Tube KICK

PROJECT:	TUBE KICK		
STATUS:	PROTOTYPE FINAL TUNING		
AUTHOR: LAURENT	DRAWING NUMBER P21-VB7-00		REV: VB7
DATE: 2015-08-07	SIZE: A4	SHEET: 1 of 1

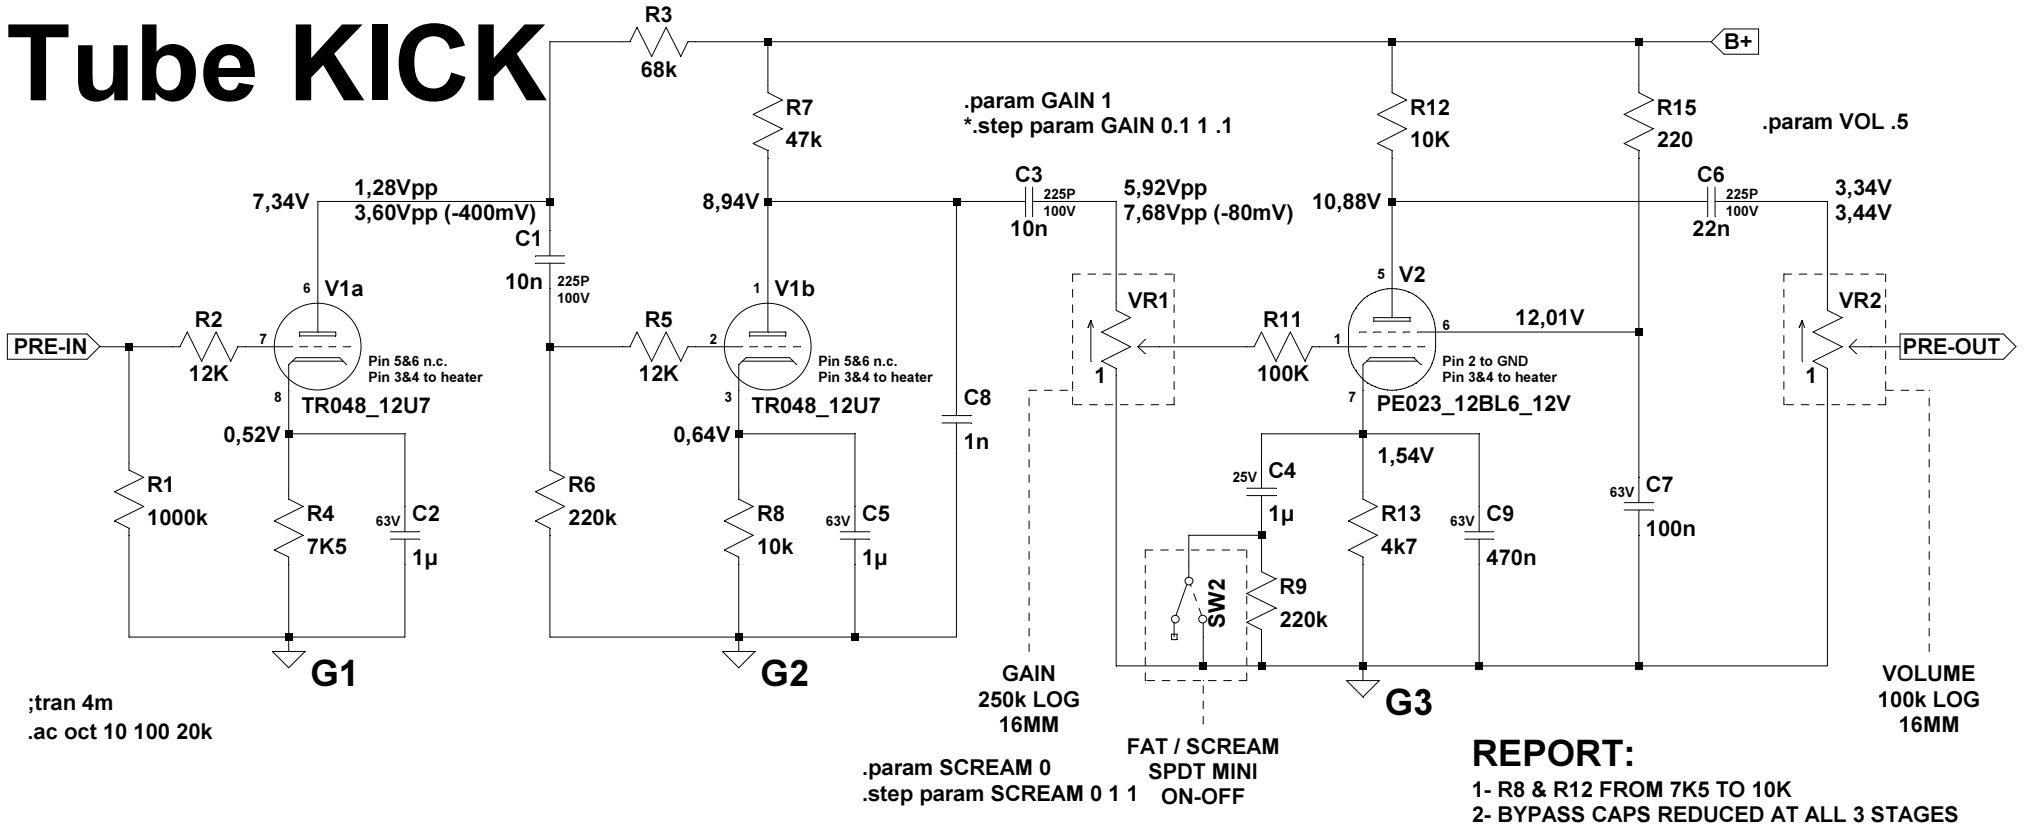
1- R8 & R12 FROM 7K5 TO 10K
2- BYPASS CAPS REDUCED AT ALL 3 STAGES
3- TIGHT SWITCH MOVED TO PENTODE
(CAN GET A SCREAM MODE OUT OF IT!)
4- TESTED VR1 AS 500K BUT SIGNAL TOO HIGH FOR V2
5- C4 WITH 2U2 ALREADY TOO MUCH BASS (MUDDY)
